**COMMUNITY DEVELOPMENT
DEPARTMENT REPORT**

HEARING DATE: 6/18/2026
 TO: Planning & Zoning Commission
 FROM: Sonya Allen, Associate Planner
 208-884-5533
 sallen@meridiancity.org
 APPLICANT: SD Land Consulting
 SUBJECT: Blueberry Hills Subdivision – AZ, PP
 H-2025-0048
 LOCATION: 4315 N. Ten Mile Rd., in the NE 1/4 of
 Section 34, T.4N., R.1W.

Annexation of 9.36 acres of land with R-4 (7.22 acres) and L-O (2.14 acres) zoning districts; and preliminary plat consisting of 24 buildable lots (20 residential & 4 commercial) and 12 common/other lots of 8.87 acres of land.

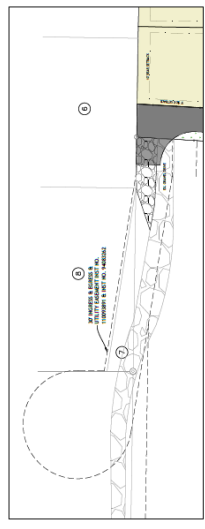
The two out-parcels will then have access via the common driveway proposed on Lot 6, Block 1 as shown below and in Section VII.H. **The driveway for Lot 5, Block 1, should be located on the opposite side of the shared property line from the common driveway.** Public street access is provided to the out-parcels for future access upon redevelopment. **Upon redevelopment of those lots, the Homeowner's Association should vacate the access easement, remove the driveway and landscape the area for use as common area for the subdivision.**

Common driveways are required to comply with the standards in UDC 11-6C-3D. One (1) common driveway is proposed on Lot 6, Block 1 for access to the two (2) out-parcels currently accessed via W. Elk Bugle Ln. (see exhibit VII.G below). The width of the asphalt driveway is 20'; the width of the lot varies from 22.74 to 27.39 feet. Six-foot-tall solid vinyl fencing is proposed along the west side of the northern portion of the driveway and along the east side. **Per UDC 11-6C-3D.5, solid fencing is prohibited adjacent to common driveways unless separated by a minimum 5' wide landscaped buffer planted with shrubs, lawn or other vegetative groundcover; the plans should be revised to comply with this standard. Directional address signage should be erected on W. Belltower Dr. for the two (2) homes accessed via the common driveway for emergency wayfinding.**

- vi. Per UDC 11-6C-3D.5, solid fencing is prohibited adjacent to common driveways unless separated by a minimum 5' wide landscaped buffer planted with shrubs, lawn or other vegetative groundcover; revise the plat and/or landscape plan as applicable to comply (i.e. change the fencing type to open vision or widen the lot).

The driveway shall be located on east side of lot per UDC 11-6C-3D.5
